Series 3700A System Switch/Multimeter

Version 1.57 Firmware Release Notes

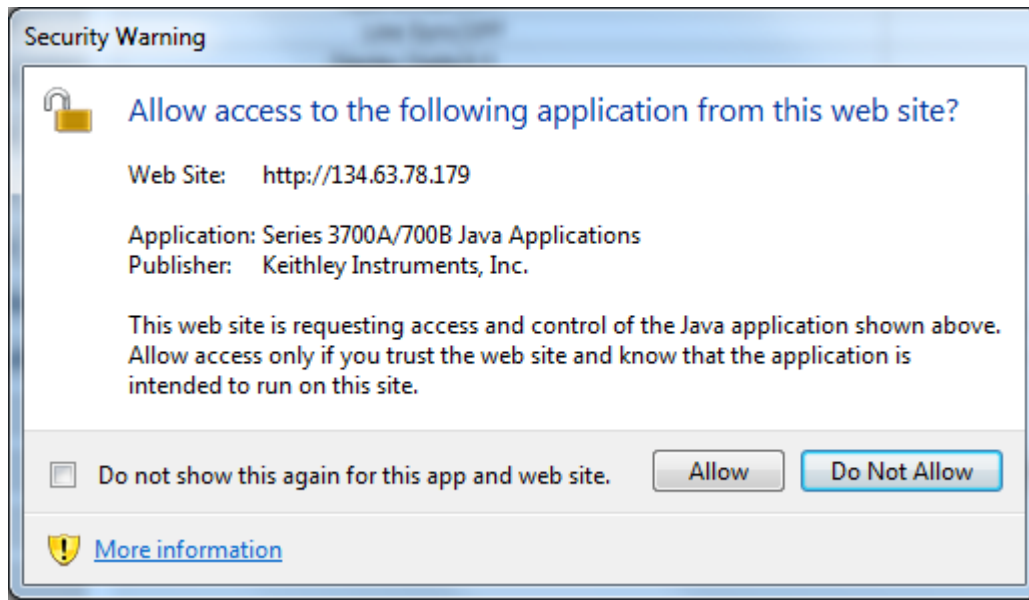
Symptom:

When switching from one web application to another for the first time, a Java security warning window similar to the one shown below is used to get the user's permission. In the most recent versions of Java (7u65 and 8u11), the security warning window appears **behind** the web browser when using Internet Explorer. Until the security warning window is acknowledged, the web browser will appear to be unresponsive. This only happens with Internet Explorer.

Workaround:

Enable the "Do not show this again for this app and web site." check-box prior to clicking the "Allow" button.
